Wisconsin Department of Transportation

Proposal #1: 1030-20-84, WISC 2018 380
N-S Freeway
South Milwaukee Roadway/Mainline
IH 94
Milwaukee County

Letting of July 24, 2018

This is Addendum No. 02, which provides for the following:

Addendum No. 02
 ID 1035-01-74
 Revised Sheet 206
 July 11, 2018

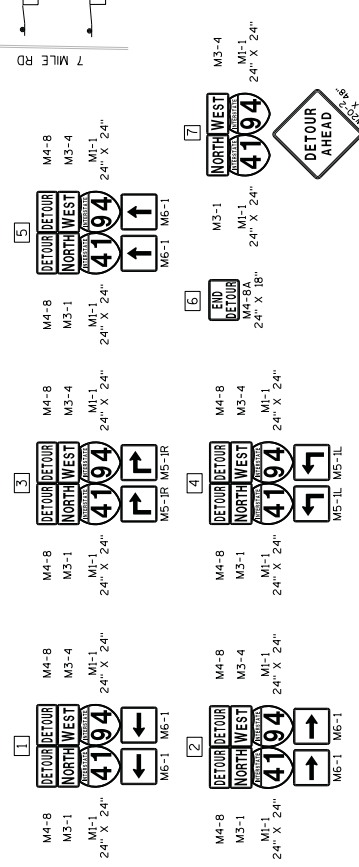
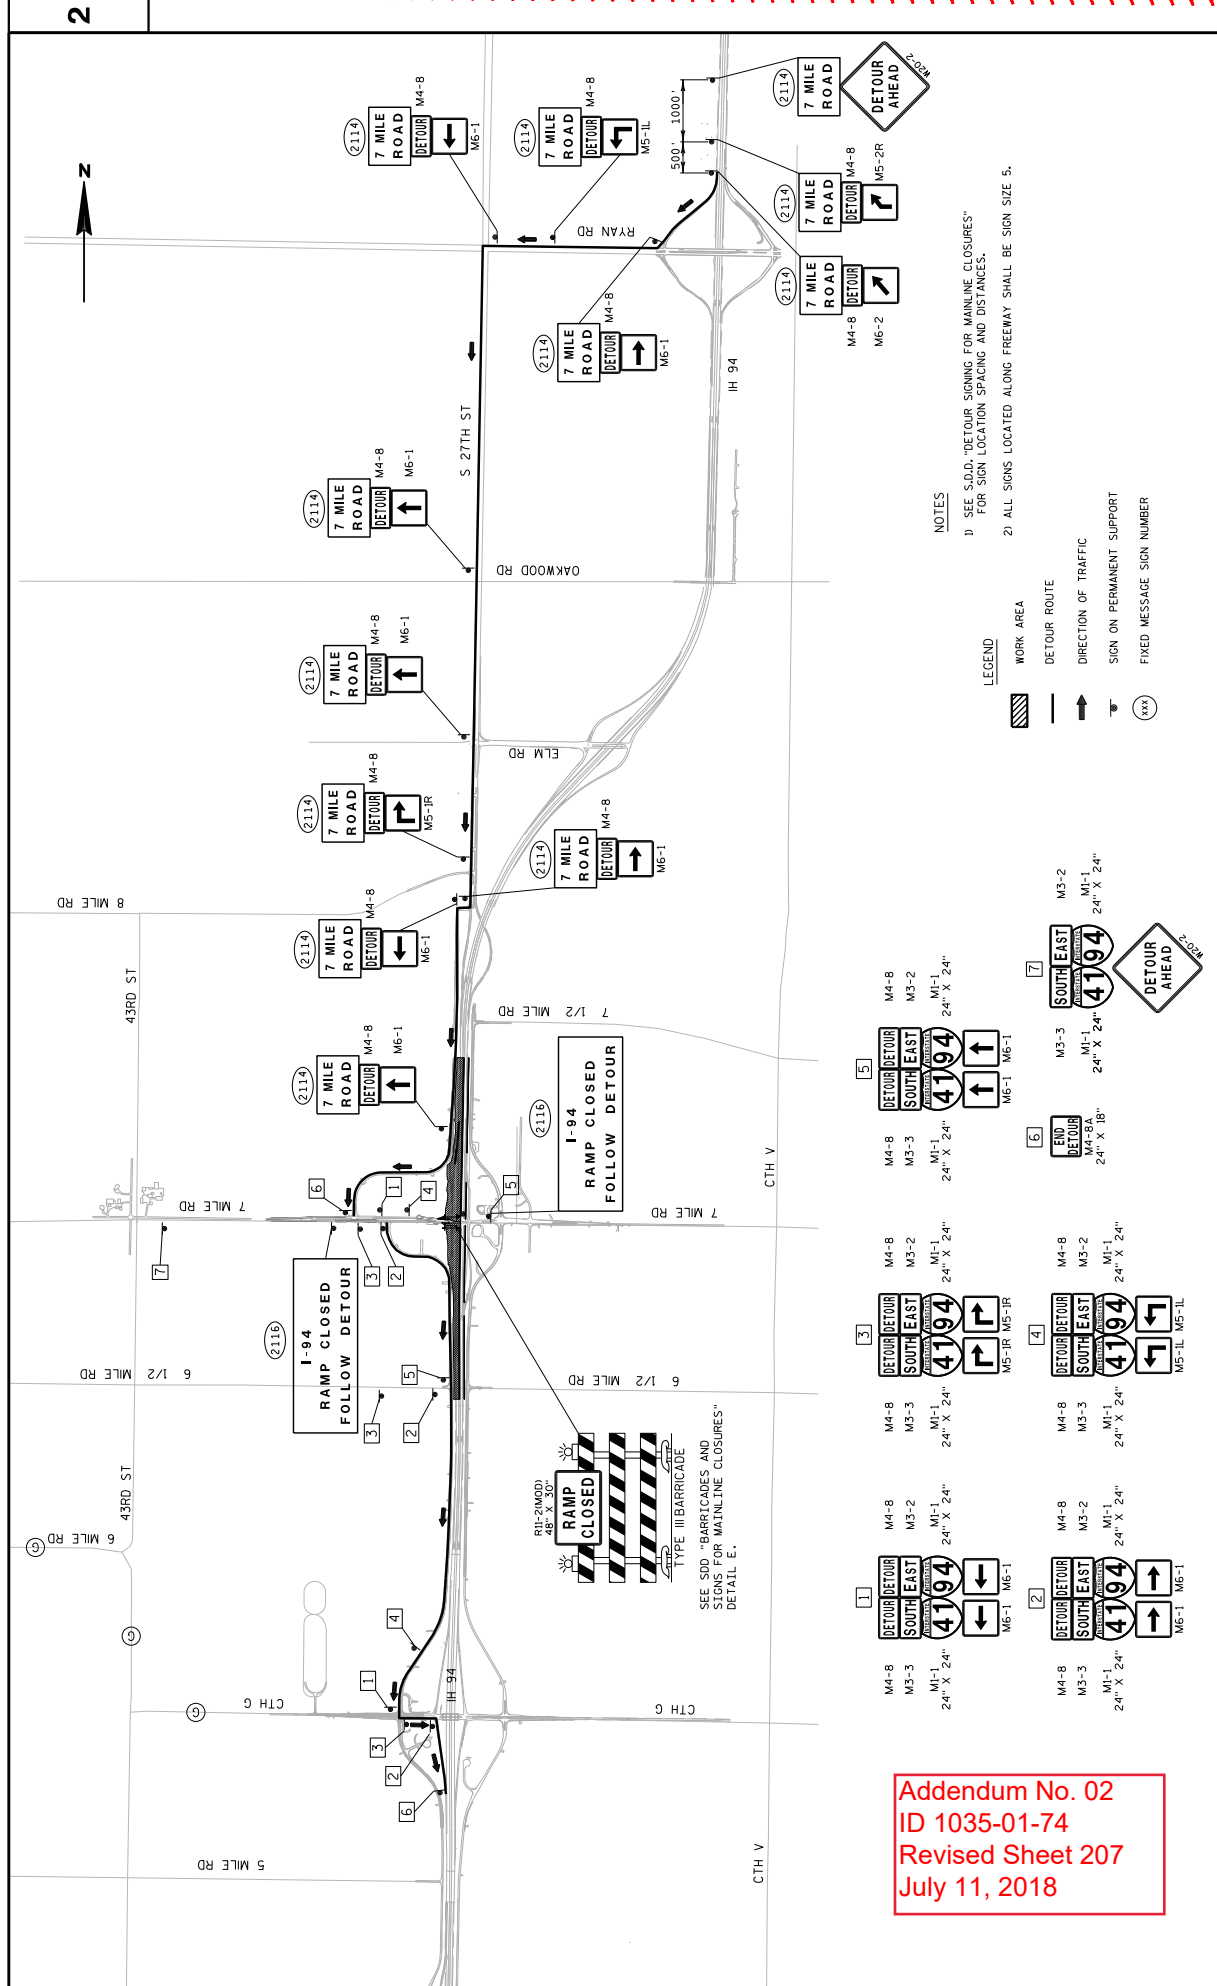
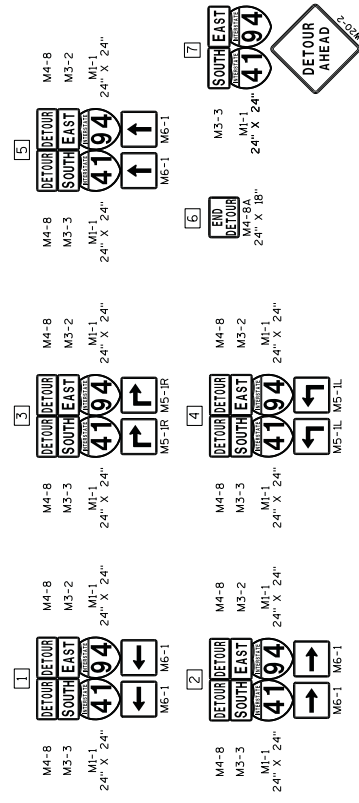
ID 1035-01-74 Revised Plan Sheets	
Plan Sheet	Plan Sheet Title (brief description of changes to sheet)
206	Detour Plan (Updated legend and traffic control signs)
207	Detour Plan (Updated legend)
209	Detour Plan (Updated legend)
231	Miscellaneous Quantities (Revised Note 2 on Earthwork Summary)
252	Miscellaneous Quantities (Redistributed traffic control sign qtys, but no overall qty change)
254	Miscellaneous Quantities (Revised Traffic Control Signs Fixed Message quantity)
469	Structure Plan B-51-139- Quantities and Design Data- Concrete and Reinforcement Quantity revised
477	Structure Plan B-51-139- Pier Geometry- Column height dimension revised
481	Structure Plan B-51-139- Pier Geometry- Column height dimension revised
487	Structure Plan B-51-139- Superstructure Details- Diaphragm Reinforcement revised
